SECTION 00 91 15

ADDENDUM NUMBER 6

- 1.01 DATE: APRIL 6, 2021**
- 1.02 PROJECT: WELCOME CENTER**
- 1.03 PROJECT NUMBER: DCM NO. 2020604**
- 1.04 OWNER: ALABAMA A&M UNIVERSITY**
- 1.05 ARCHITECT: NOLA | VAN PEURSEM ARCHITECTS, PC**

SHEET NUMBER
A-7.3
OF

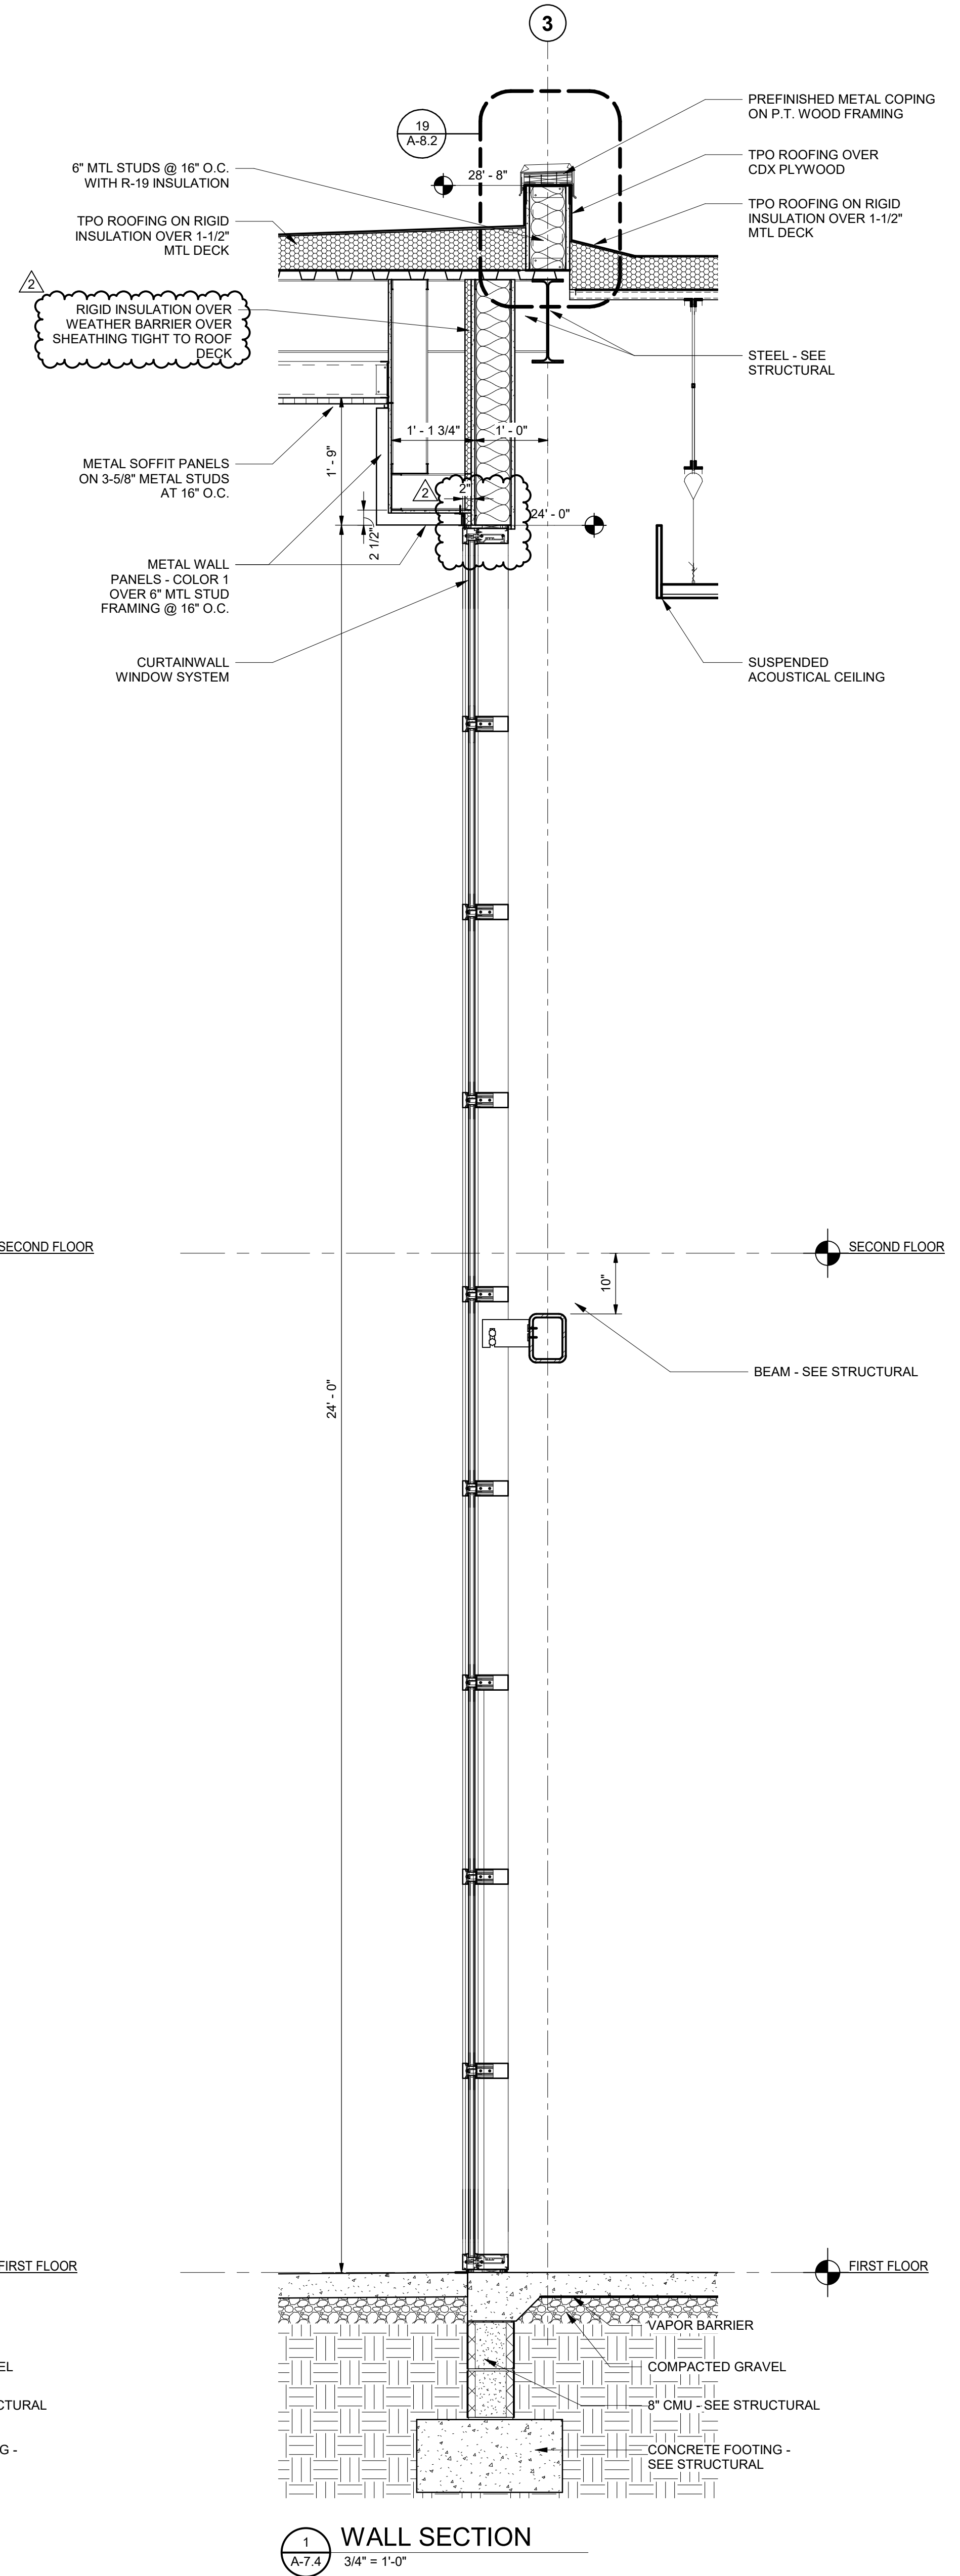
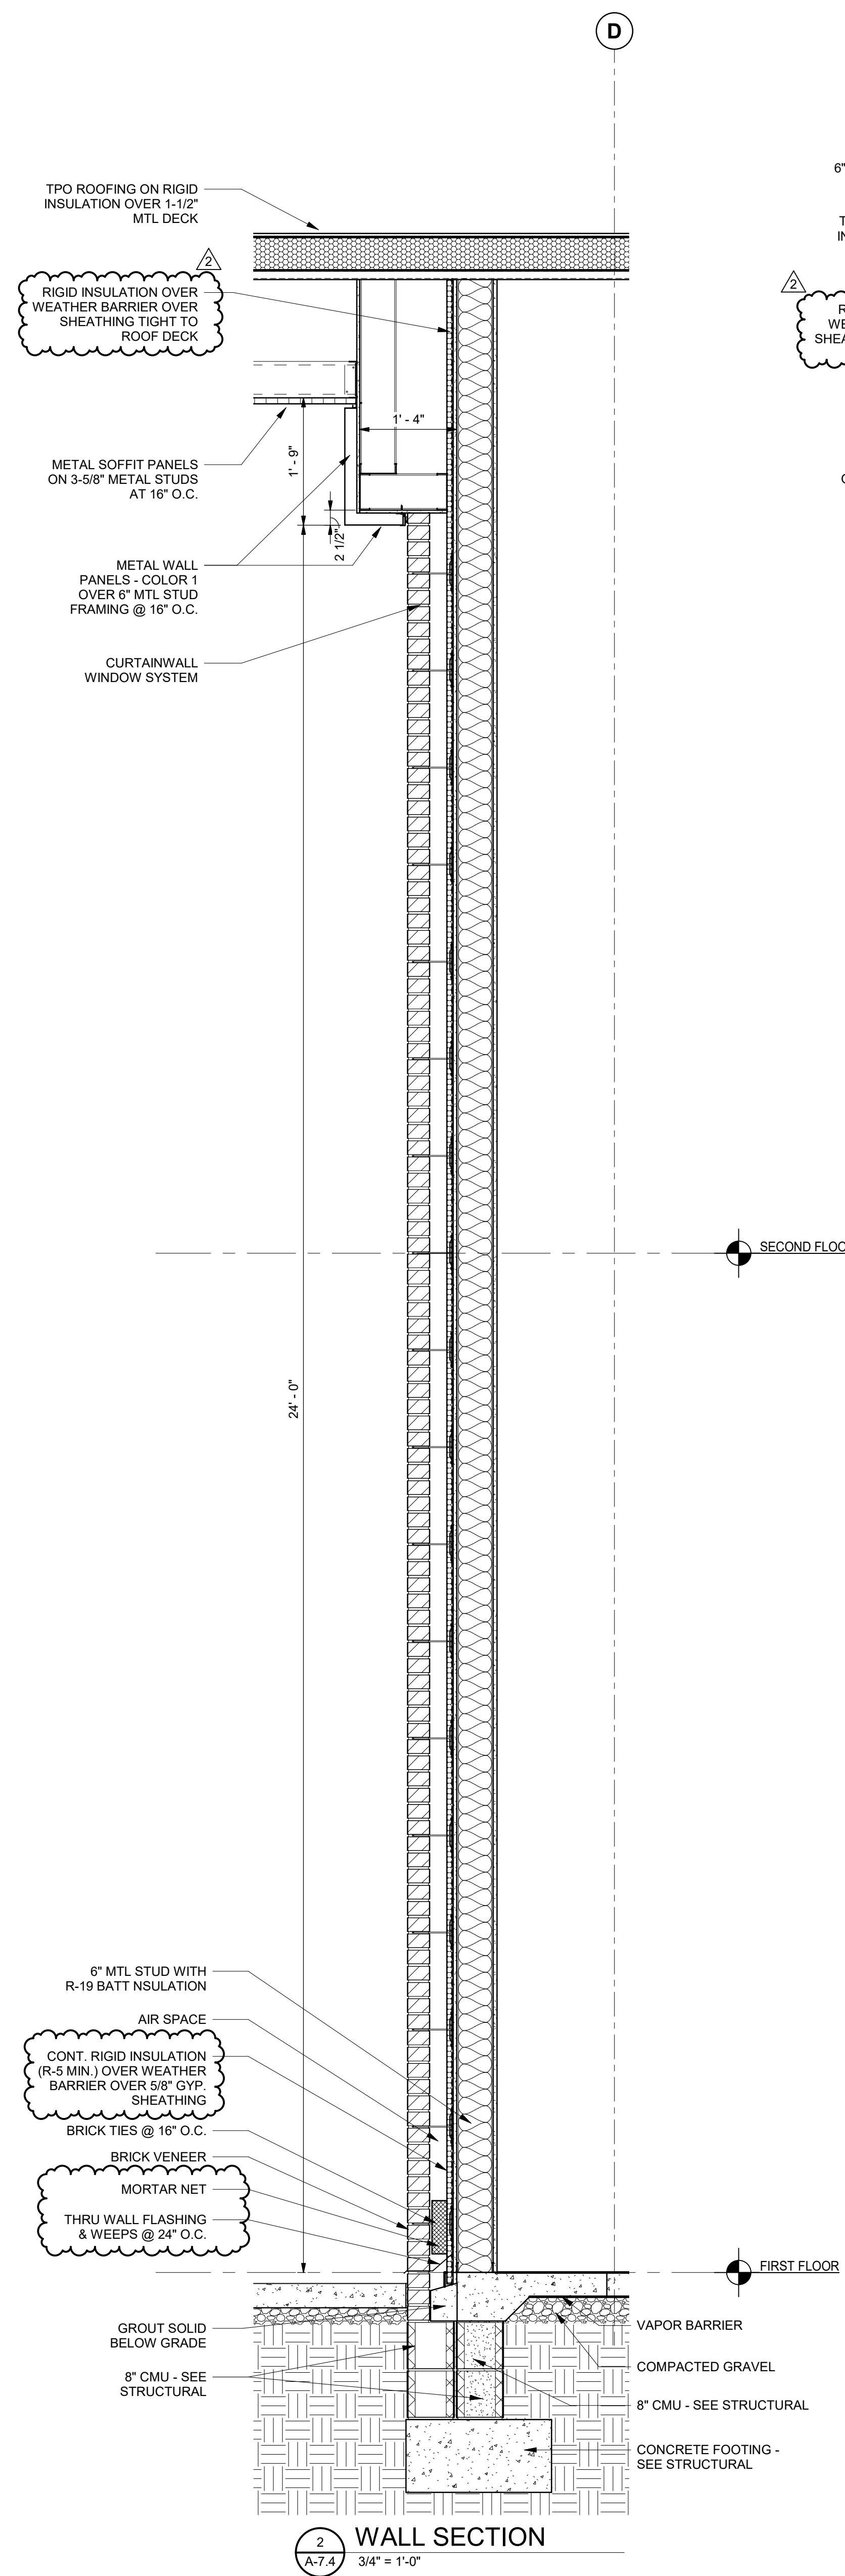
4.15 SHEET A-7.3 – WALL SECTIONS:

- A. Replace this sheet in its entirety. Revisions include the following:
1. Updated notes regarding weather barrier, mortar net, and vapor barrier.
